REGIONAL REVIEW NOTICE

ARC REVIEW CODE: R1001271

Name of Proposal: Coffee Road MRF

Description: This project, located in DeKalb County, is a proposed 80,000 square foot recycling center that will sort, bale and store recyclable material for delivery to processing facilities. The proposed project is located at 2183 Coffee Road, north of the intersection of Stone Mountain-Lithonia Road and Lithonia Industrial Boulevard.

1. THE RACK ELEMENT

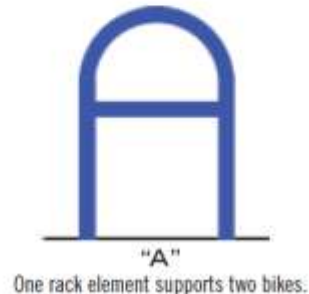
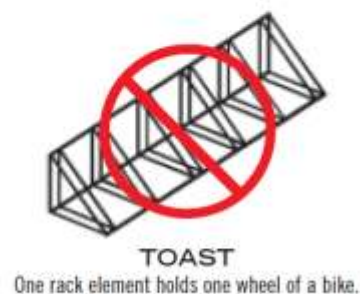
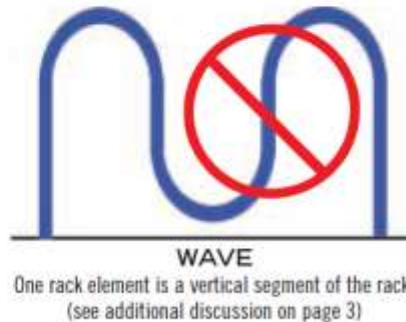
The bicycle rack is identified on the site plan, and should be installed in accordance with best practices. APBP Bicycle Parking guidelines are suggested, as illustrated in the figure below:

The rack element should:

- Support the bicycle upright by its frame in two places
- Prevent the wheel of the bicycle from tipping over
- Enable the frame and one or both wheels to be secured
- Support bicycles without a diamond-shaped frame with a horizontal top tube (e.g. a mixte frame)
- Allow front-in parking: a U-lock should be able to lock the front wheel and the down tube of an upright bicycle
- Allow back-in parking: a U-lock should be able to lock the rear wheel and seat tube of the bicycle

Comb, toast, school-yard, and other wheel-bending racks that provide no support for the bicycle frame are NOT recommended.

The rack element should resist being cut or detached using common hand tools, especially those that can be concealed in a backpack. Such tools include bolt cutters, pipe cutters, wrenches, and pry bars.
